Second Revision No. 1050-NFPA 99-2022 [Global Comment]

Committee: HEA-ELS

Figure B.6.1 Typical Hospital Wiring Arrangement.

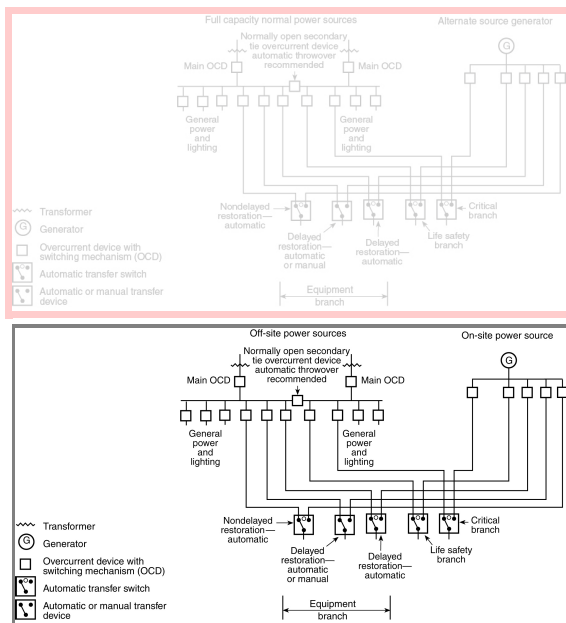
Second Revision No. 1124-NFPA 99-2022 [Section No. B.6.1]

See Figure B.6.1. Separate transfer switches for each branch, as shown, are required only if dictated by load considerations. Smaller facilities can be served by a single transfer switch.
